## Executive Director's Recommendation

Commission Meeting: February 2, 2017

| <b>PROJECT</b><br><b>Dwight D. Eisenhower Memorial Modification</b><br>National Mall and Memorial Parks<br>Bound by Independence Avenue, 4th Street, and 6th Streets, SW and by the Lyndon B. Johnson Department of Education Headquarters Building<br>Washington, DC | <b>NCPC FILE NUMBER</b><br>6694<br><br><b>NCPC MAP FILE NUMBER</b><br>1.71(38.00)44490<br><br><b>APPLICANT'S REQUEST</b><br>Approval of comments on revised concept design |
| <b>SUBMITTED BY</b><br>United States Department of the Interior, National Park Service on behalf of the Dwight D. Eisenhower Memorial Commission  | <b>PROPOSED ACTION</b><br>Approve comments on revised concept design   |

# Summary of Design Revisions since the July 2015 NCPC Final Approval

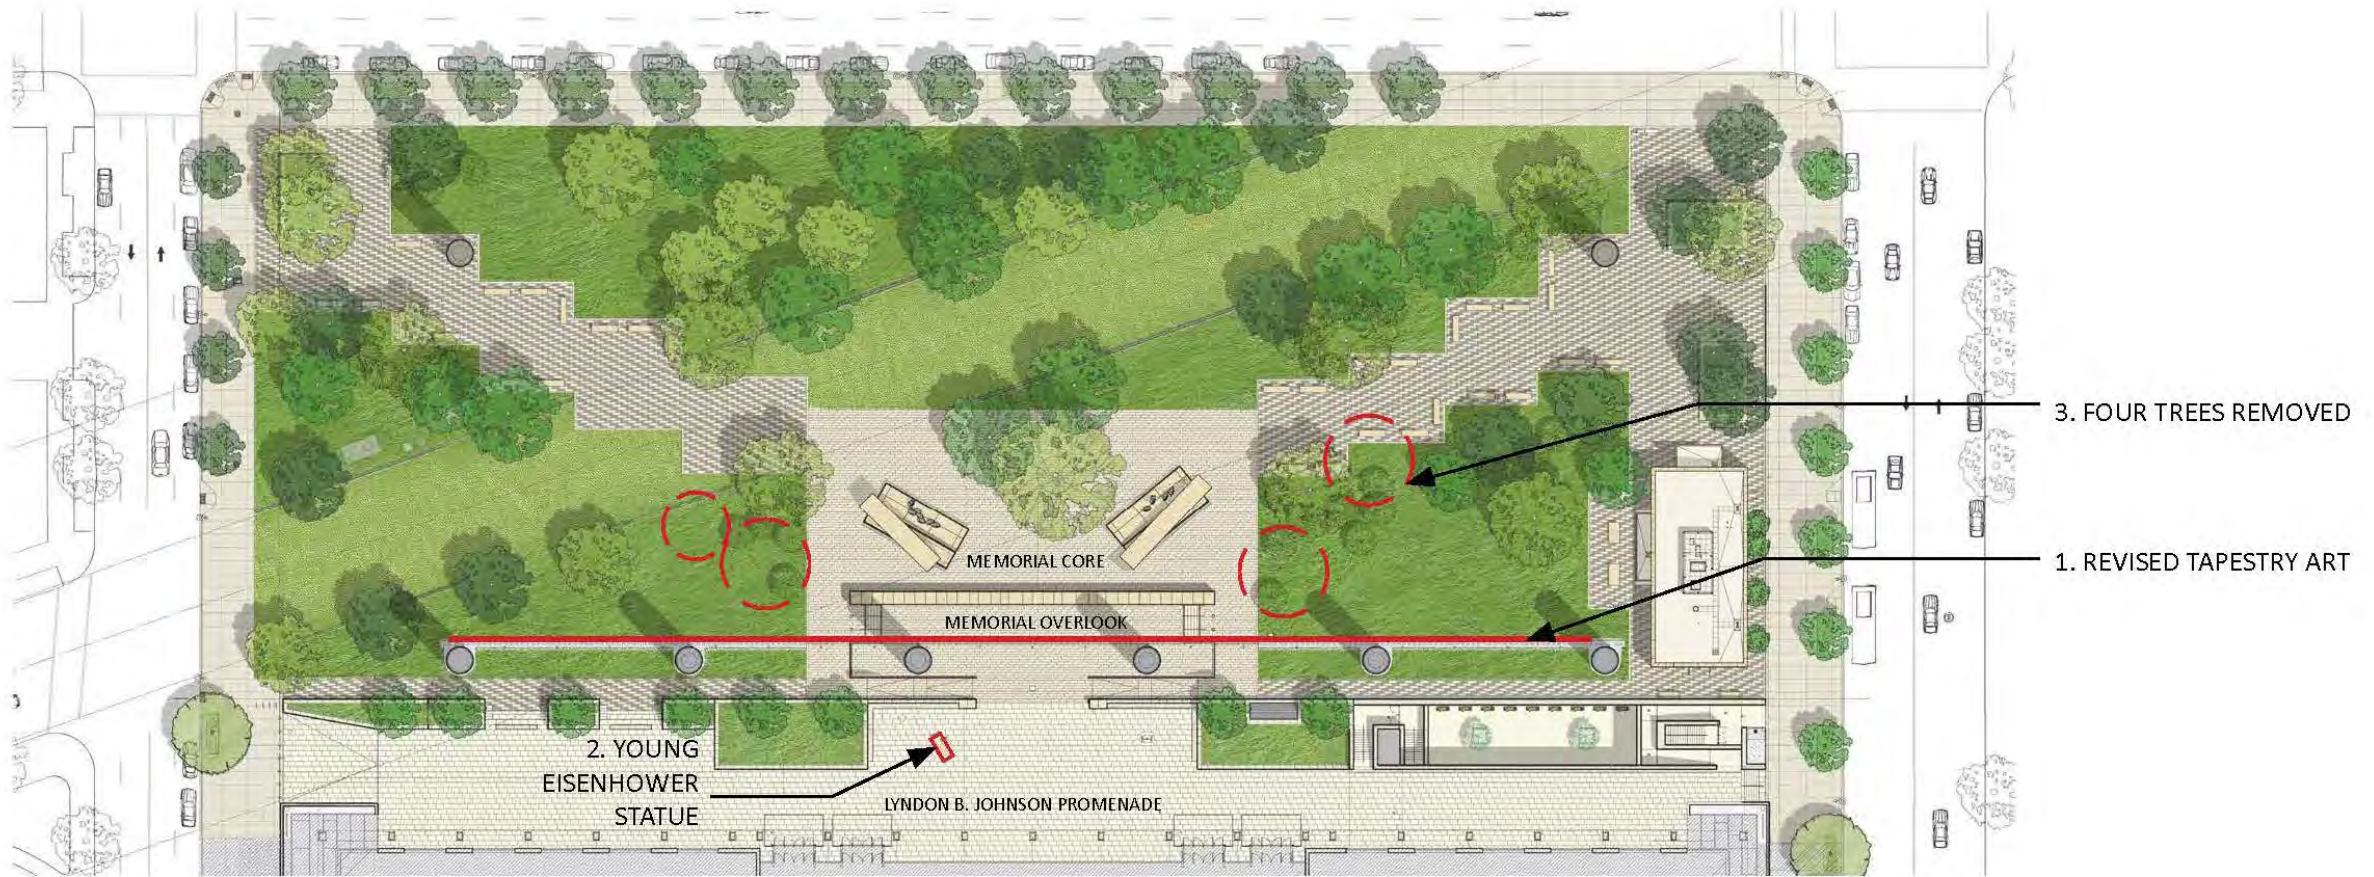
1. **Memorial Tapestry:** Revising the artistic image on the tapestry, and the symbolic context of the story of Eisenhower from a landscape scene of Abilene, Kansas, Eisenhower's hometown, meant to honor Eisenhower's Midwestern core values of strength, modesty, and integrity, to a contemporary and peaceful scene of the Normandy coastline, from the sea looking towards the land. The image includes Omaha and Utah Beaches with Pointe du Hoc at the center, in remembrance of the sacrifices of D-Day. The coast of Normandy remains a symbolic reminder of this key event that led to peace and shaped our nation's history in the years that followed.

2. **Young Eisenhower Sculpture:** Relocating the statue of young Eisenhower from the Memorial Overlook to the LBJ Promenade near the Department of Education entrance to strengthen the thematic relationship between the memorial and the Department of Education. The sculpture will be seated on a three-foot-tall wall, which will include an inscription from Eisenhower's Abilene Homecoming speech.

3. **Canopy Tree Plan:** Removing approximately four canopy trees adjacent to the memorial core to increase the views of the revised tapestry image.

Diagram of south tapestry showing estimated image densities (in percent solid) - Current Design

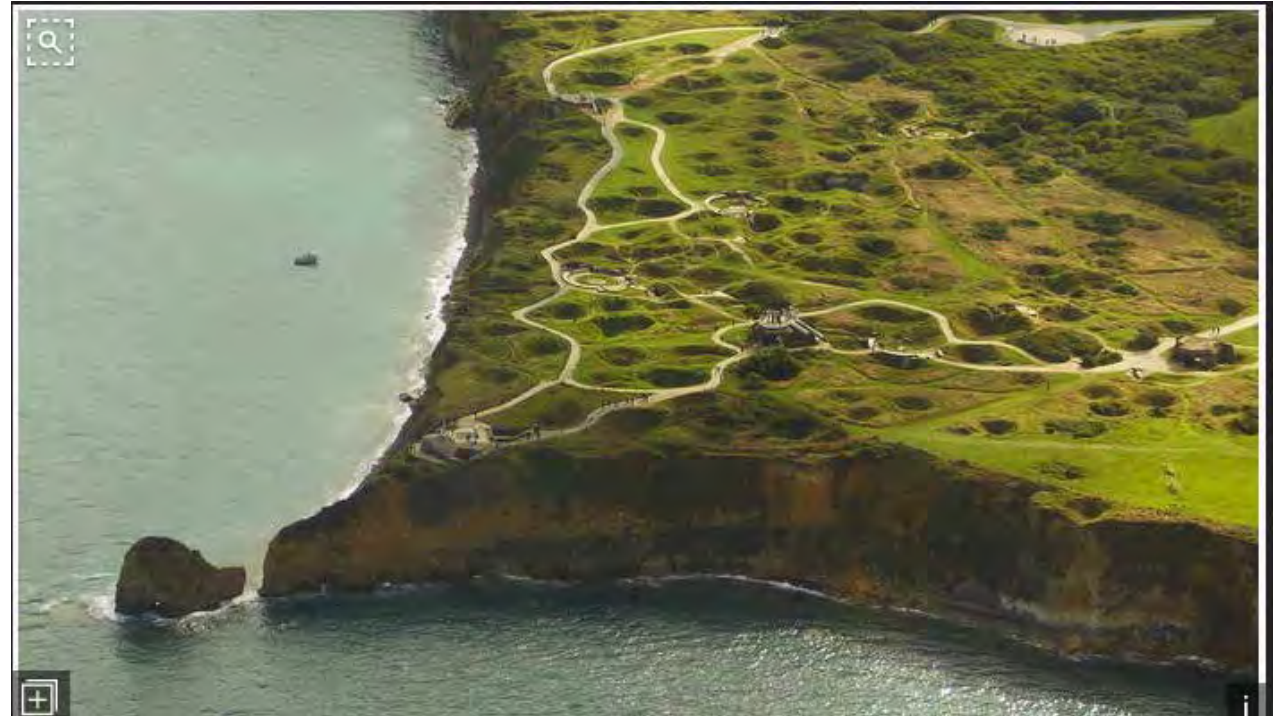
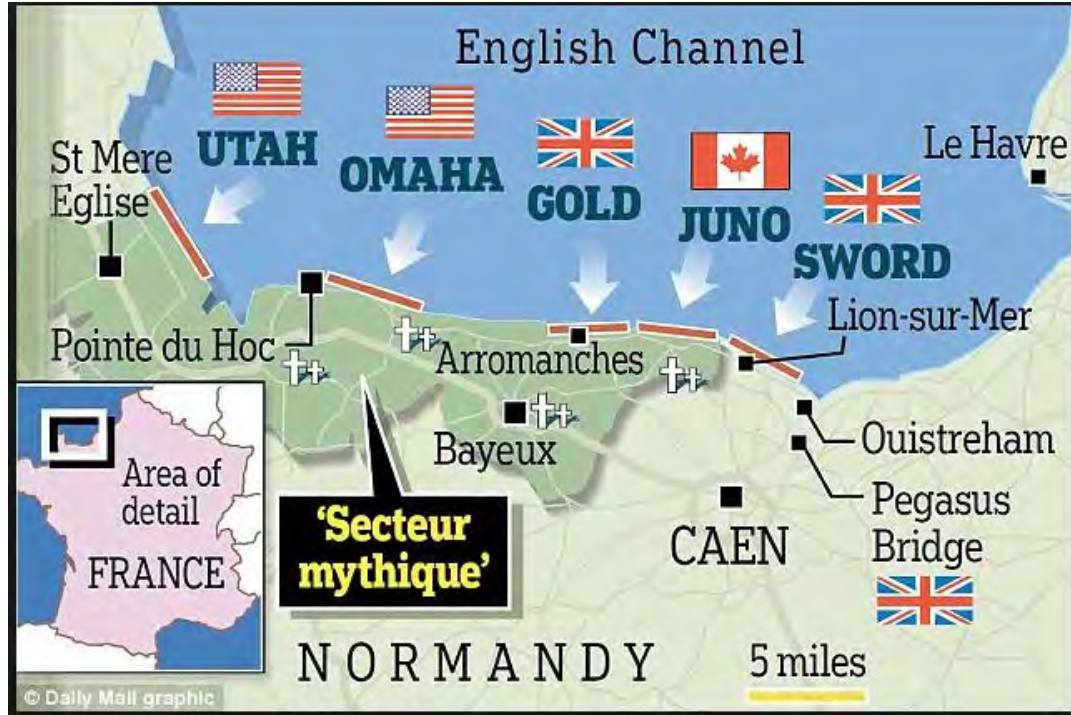
the original approved tapestry image will be maintained in the newly proposed design. The bottom 1/3 will be a maximum of 95 percent opaque, the middle 1/3 will be 50 percent opaque and the top 1/3 will be 20 percent opaque. As the design continues to evolve, staff recommends that the Commission **request additional visual studies and an mock-up of the revised tapestry that address any impacts to the Lyndon B. Johnson Department of Education Headquarters (LBJ building) including views of the building through the tapestry, the memorial itself and surrounding context.**

**Requests** additional visual studies and a mock-up of the revised tapestry that address any impacts to the Lyndon B. Johnson Department of Education Headquarters including views of the building through the tapestry, the memorial itself, and surrounding context.

Revised – LBJ promenade looking west at Eisenhower as a young man

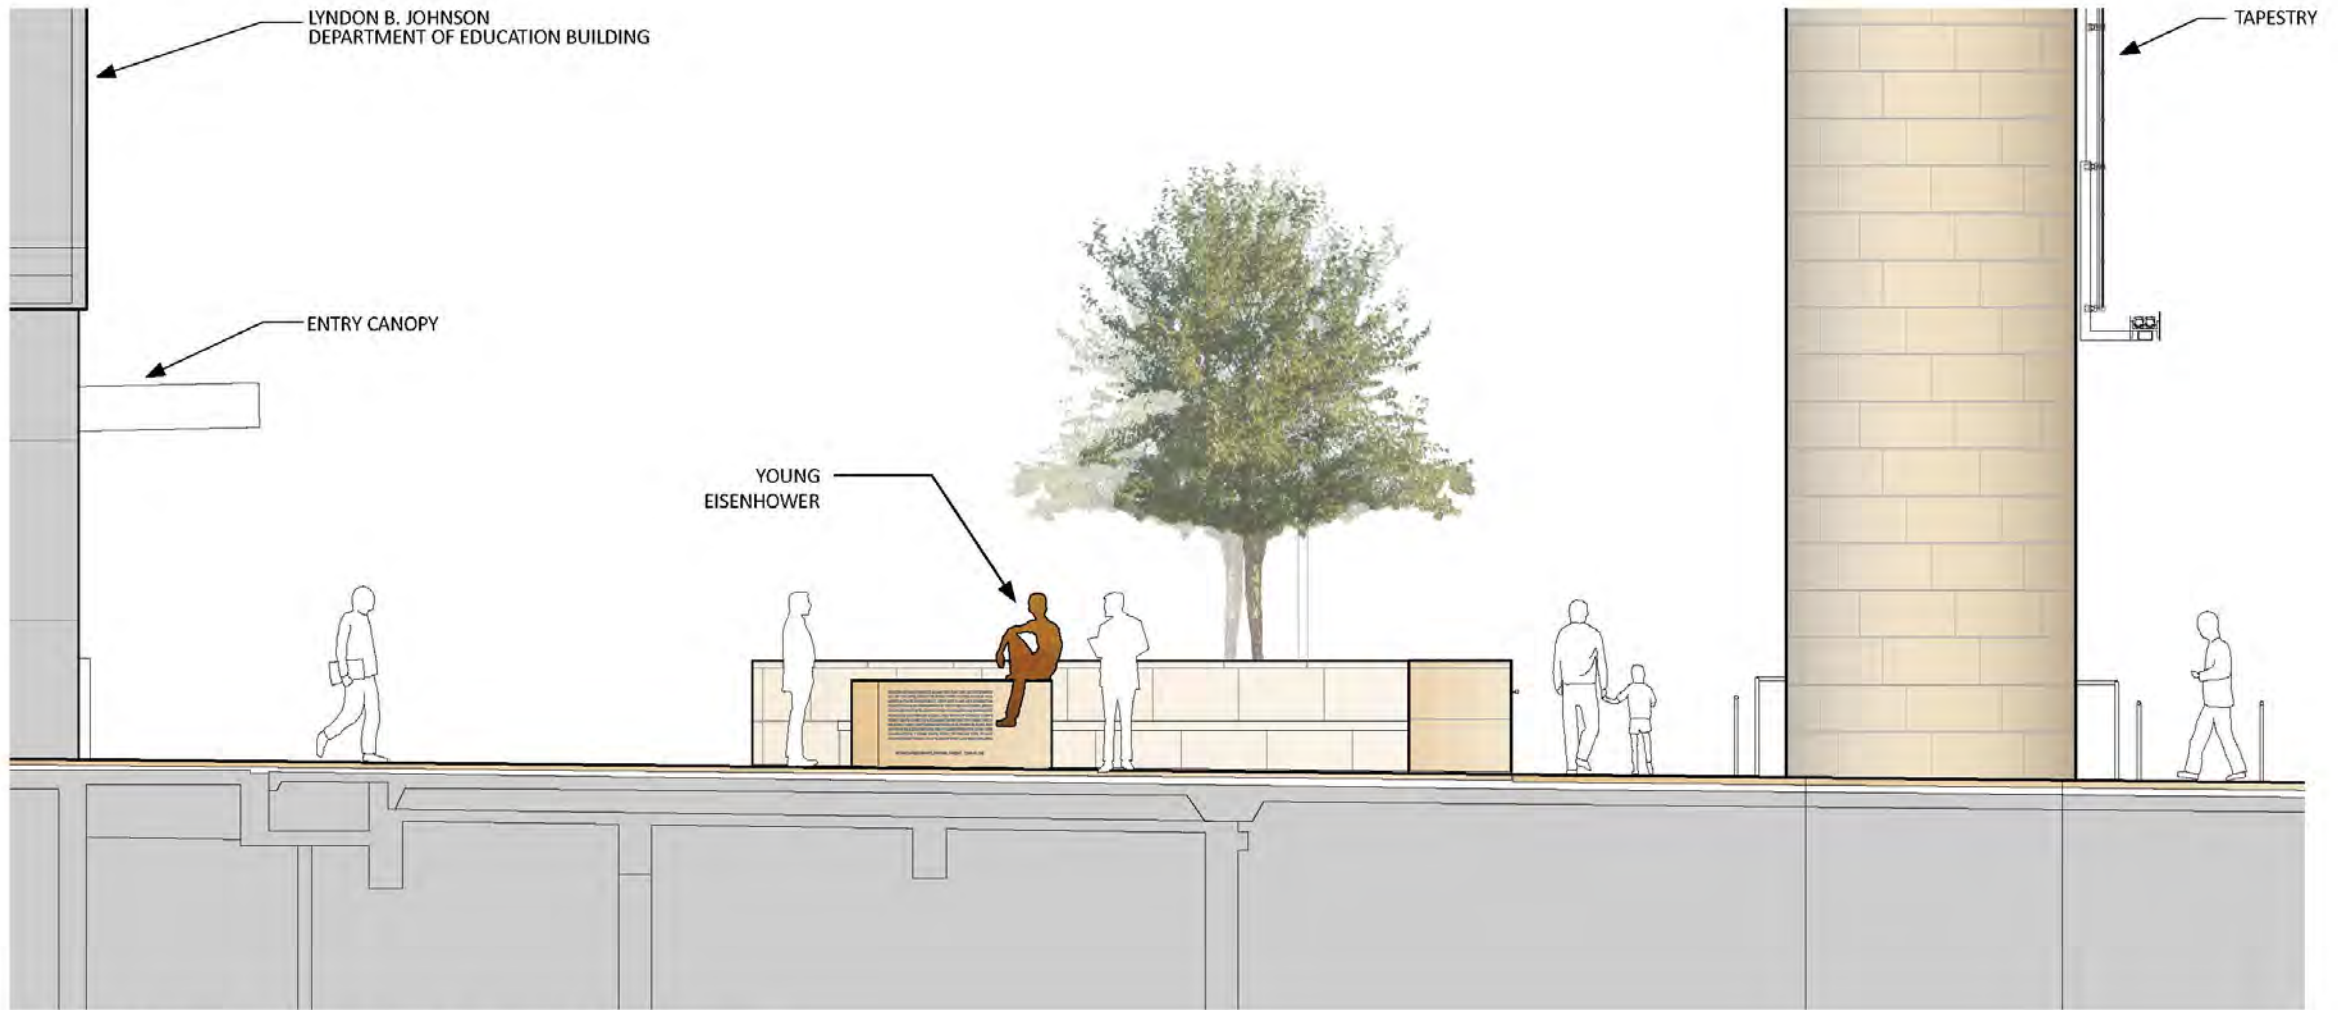
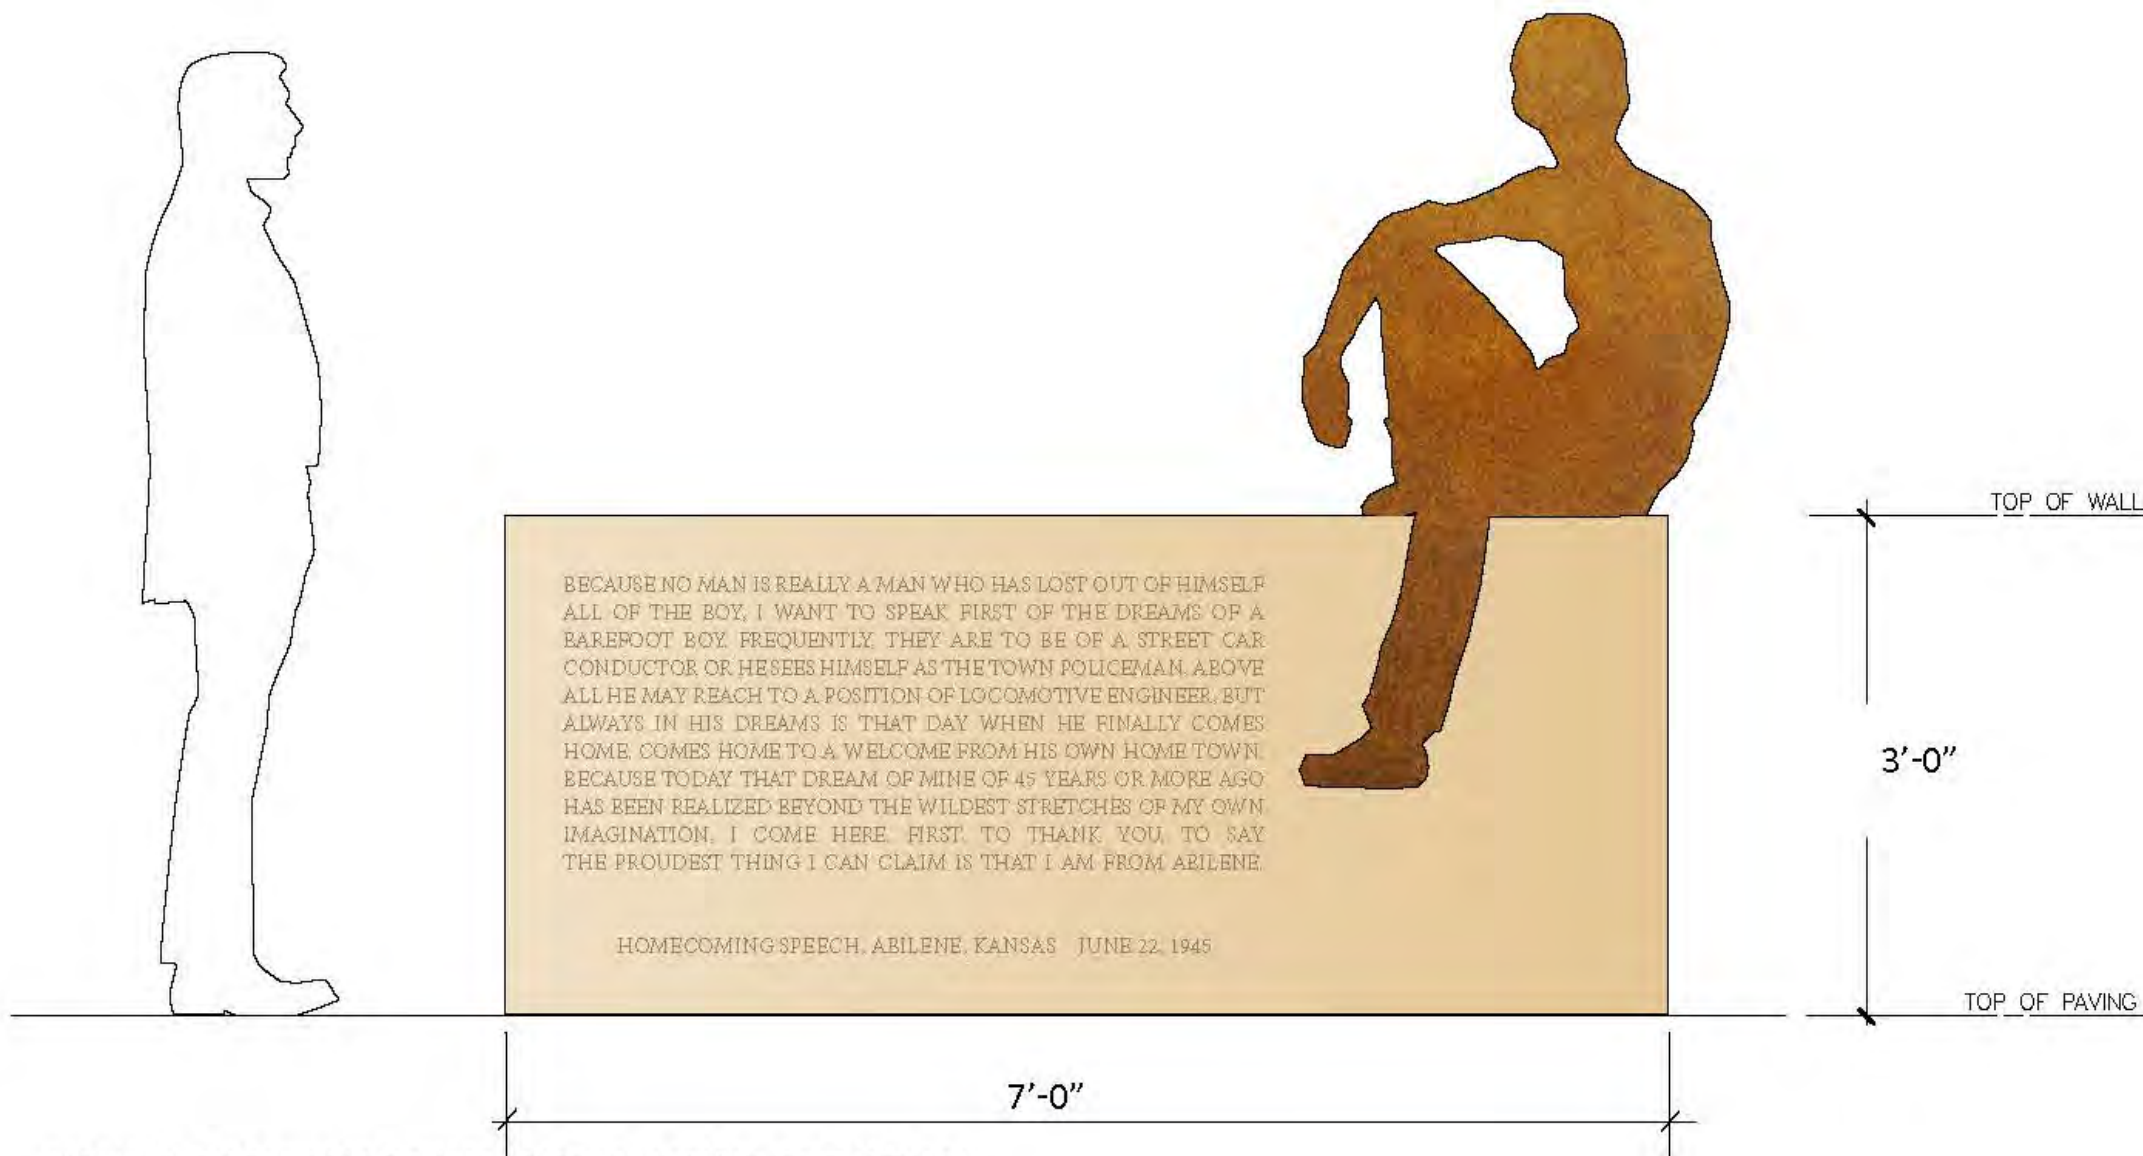
Since the image on the tapestry will be revised from a Kansas landscape, which represented his childhood and humble beginnings, to a Normandy coast scene, representing his achievements and the most complex military action in history, the relationship between the young Eisenhower sculpture and the image of his hometown is no longer relevant. Therefore, staff supports the proposed young Eisenhower statue relocation and encourages the applicant to continue to coordinate with the Department of Education and GSA. The design slightly modifies the memorial organization, based on the notion of an object within a temple within a surrounding precinct, similar to the Lincoln Memorial. However, staff finds that the relocation of the statue from the memorial core to the promenade will open new opportunities to reinforce the thematic connection between Eisenhower and the Department of Education.

The sculpture will still be in close proximity to the memorial core, retaining the axial relationship with the LBJ Building entrances, and will provide a friendly transition between the monumental tapestry and the human scale at the pedestrian promenade. The revised young Eisenhower sculpture will be life size, the same size as the previously approved sculpture on the overlook. The relocation of the sculpture will provide a more informal yet intimate setting that welcomes visitors into the promenade to learn more about the Department of Education. The sculpture relocation is consistent with the proposed programming of the promenade. The young Eisenhower sculpture will now be located on a low wall, and will be more approachable to pedestrians, instead of looking up to the overlook wall where it was previously seated, the sculpture can be appreciated at eye level.

**Requests** a revised lighting plan consistent with the overall lighting design for the memorial that considers the relocated young Eisenhower sculpture and its associated inscription wall.
